**Date:** March 9, 2022

**Subject:** Falcon Commerce Center Filing No. 2 - Civil Construction Plans

FALCON COMMERCE CENTER FILING NO. 2  
CIVIL CONSTRUCTION PLANS  
TERRAZZO DRIVE EXTENSION AND UTILITY IMPROVEMENTS  
MONUMENT, COLORADO

**FALCON COMMERCE CENTER FILING NO. 2**  
**CIVIL CONSTRUCTION PLANS**  
**TERRAZZO DRIVE PLAN AND PROFILE**  
MONUMENT, COLORADO

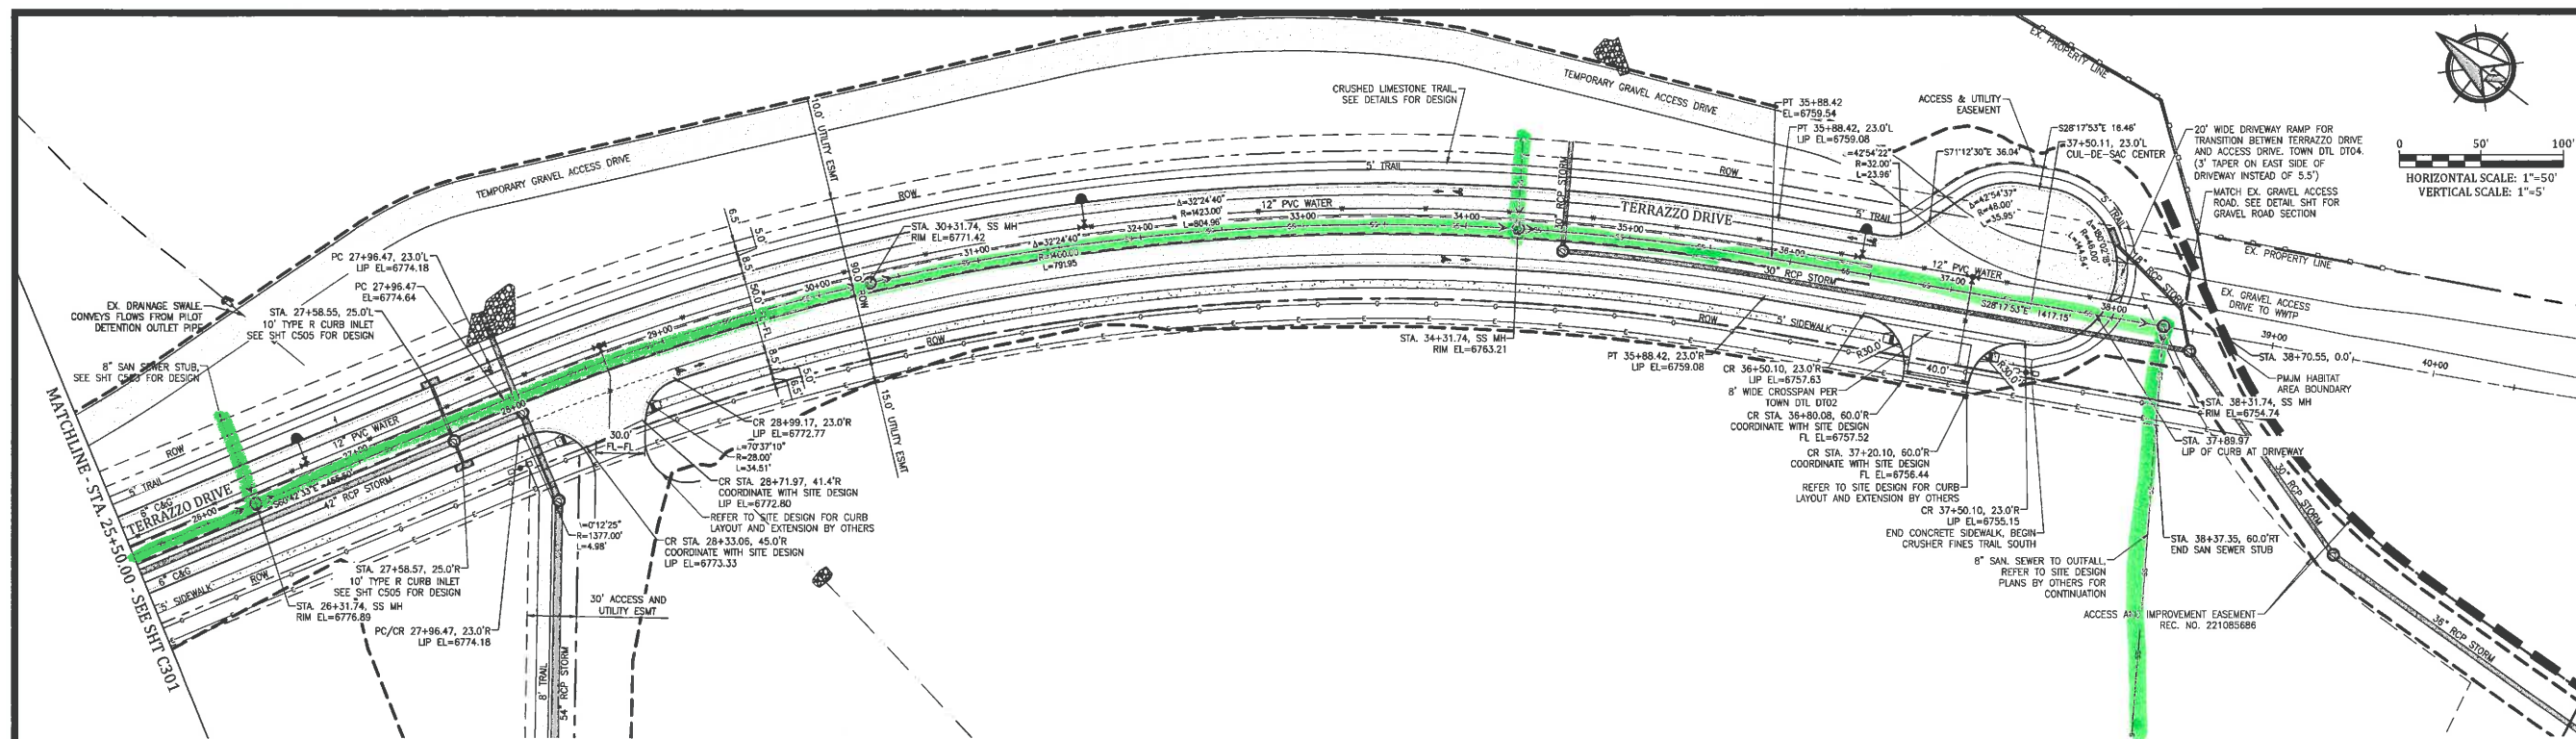
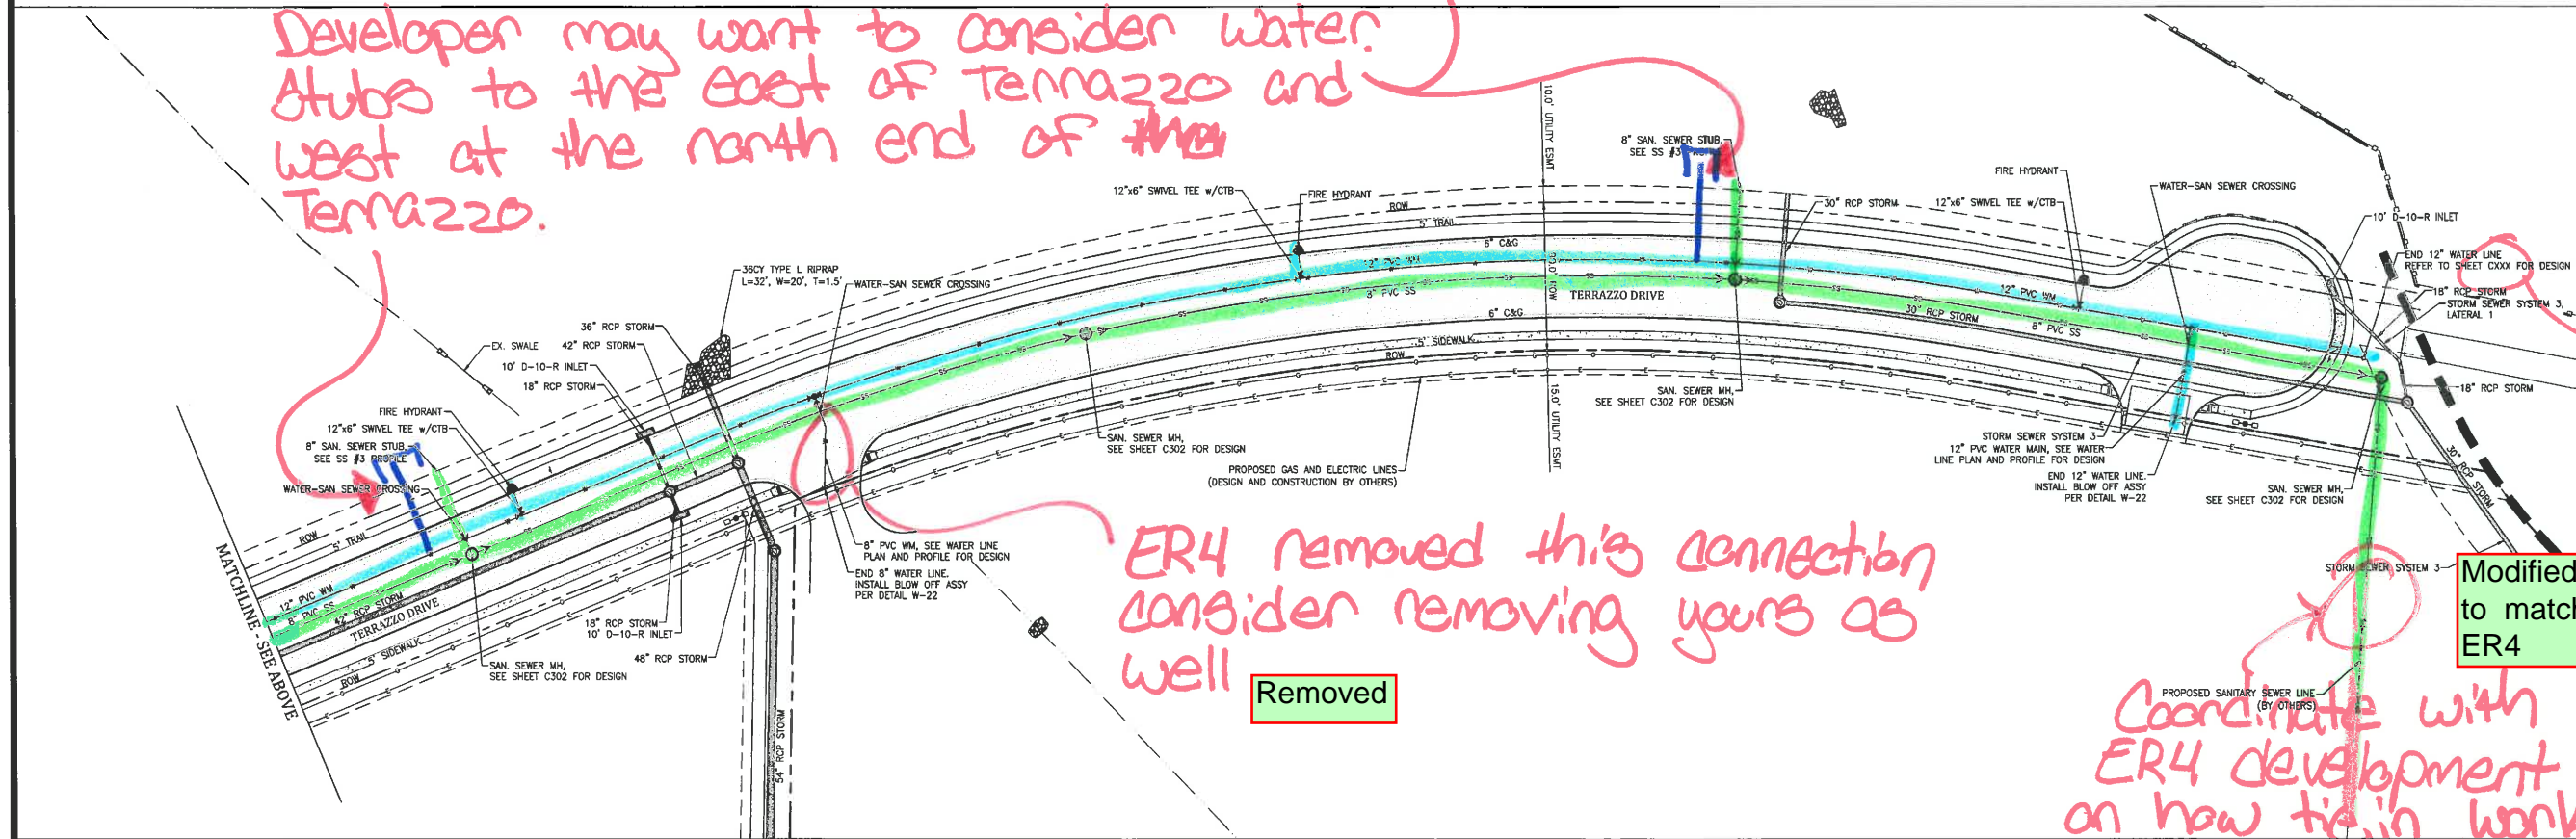
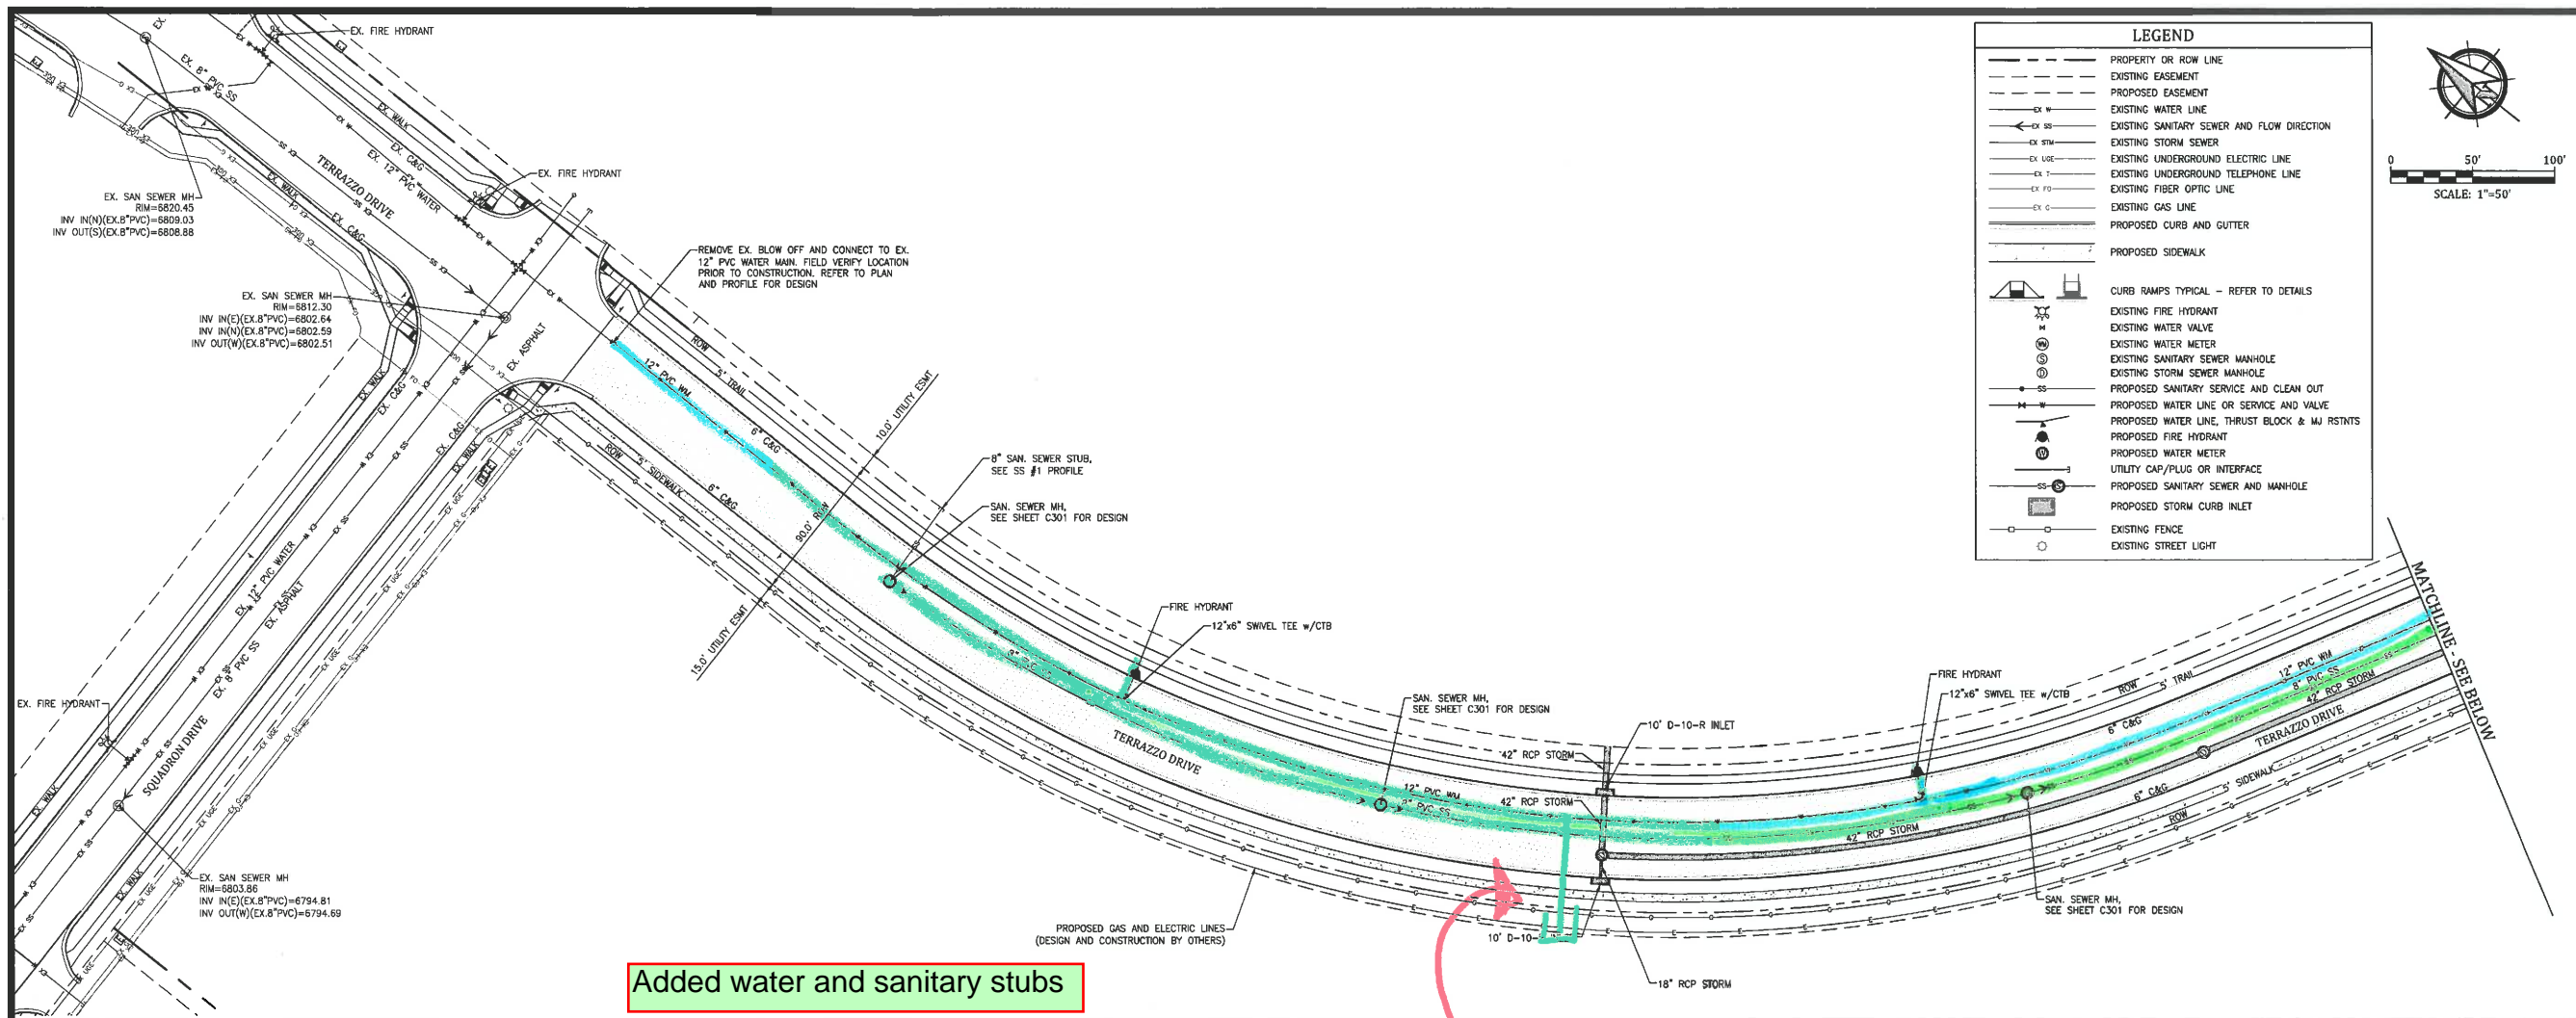
- / On Sheet C301, C302, and C513, the required drop through a sanitary sewer manhole is 0.2-feet
- / On Sheet 302, when multiple sewer pipes enter the same manhole, the crowns of the influent pipes match in elevation.
- / ON Sheet C501, the sanitary sewer connection in the cul-de-sac on the south end of Terrazzo Dr. does not match the Eagle Rock design. Coordinate with Eagle Rock to ensure both FCC and Eagle Rock designs match at the connection point between the two plan sets.

0.20' drop through manhole required

Modified all san MHs to have 0.2' drops. Crowns for laterals/main match

SHEET  
**C501**  
OF 26 SHEETS

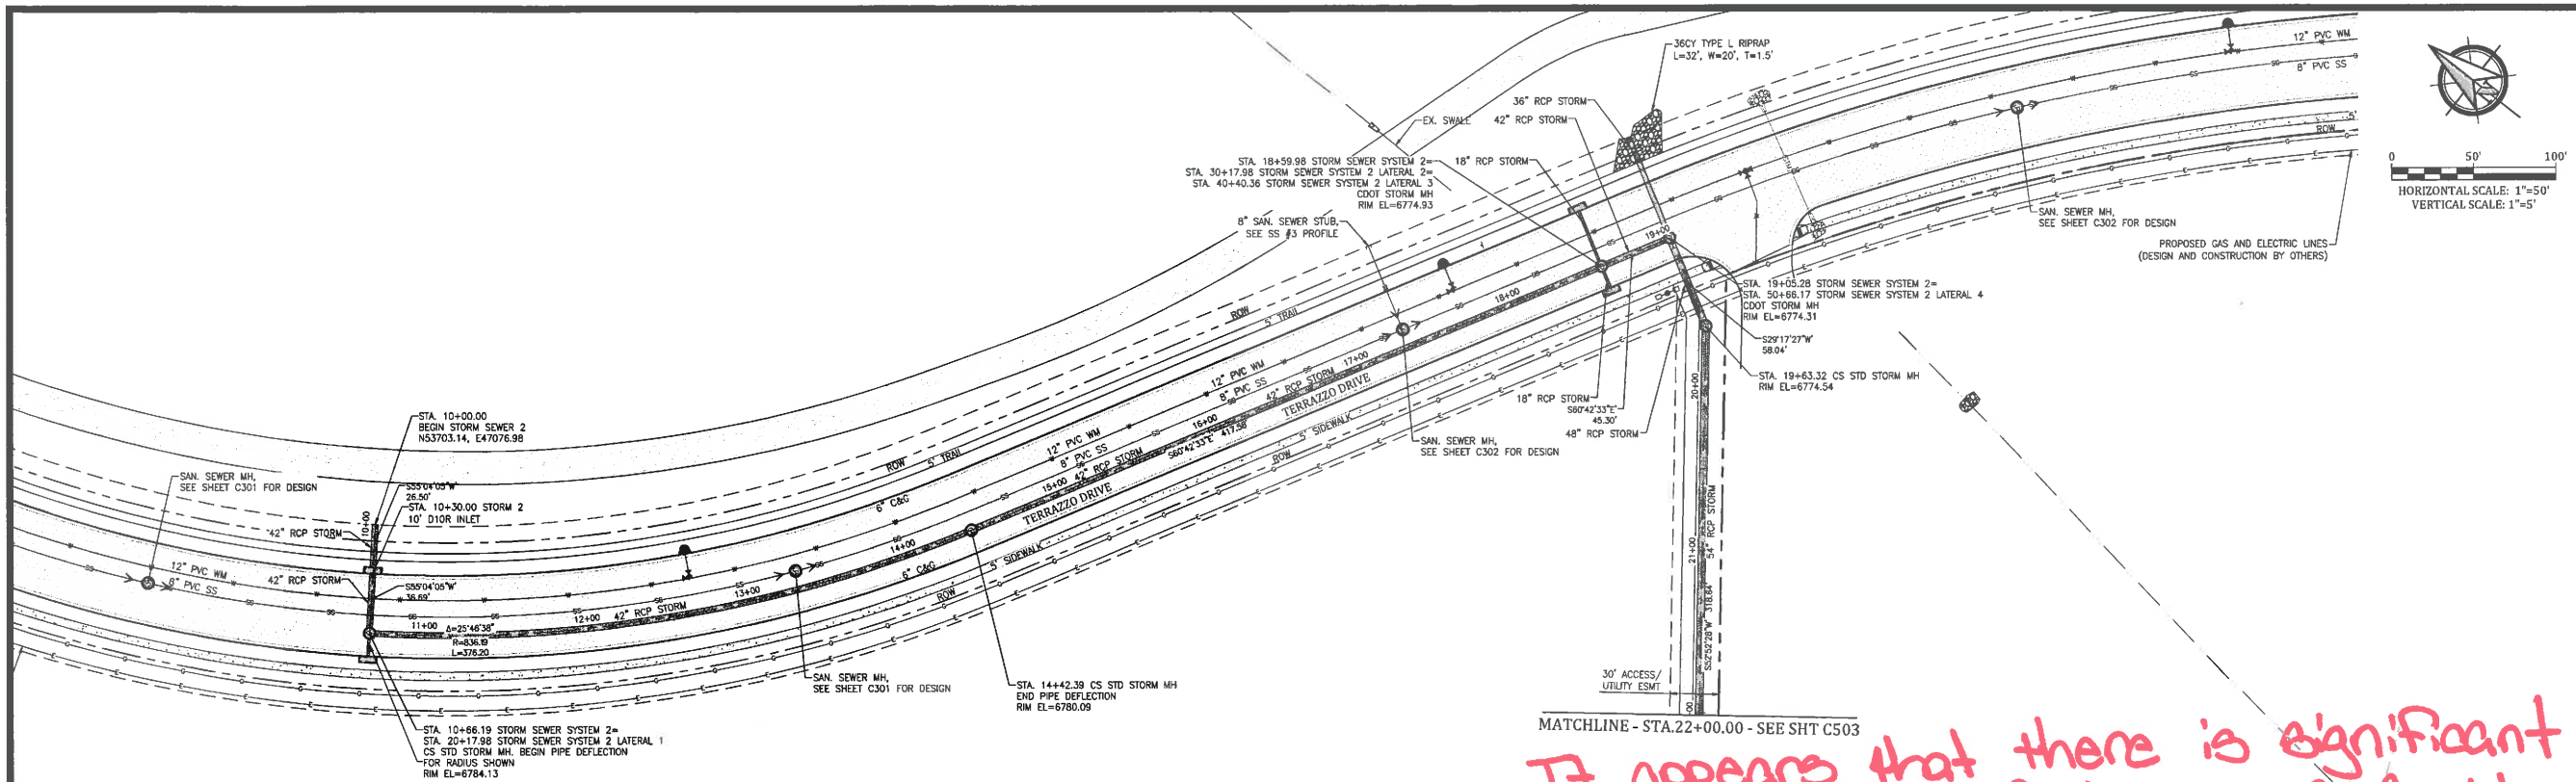
/ On Sheet C501, the northern 8-inch water stub meant to connect to the Eagle Rock parcel has been removed by Eagle Rock. Consider removing that connection.

/ On sheet C501, a note at the end of the 12-inch water line refers to sheet CXXX for design. Update CXXX to the correct sheet.

Coordinate with  
ER4 development  
on how tie-in work  
and where it is.

Added  
What sheet

Modified  
to match  
ER4
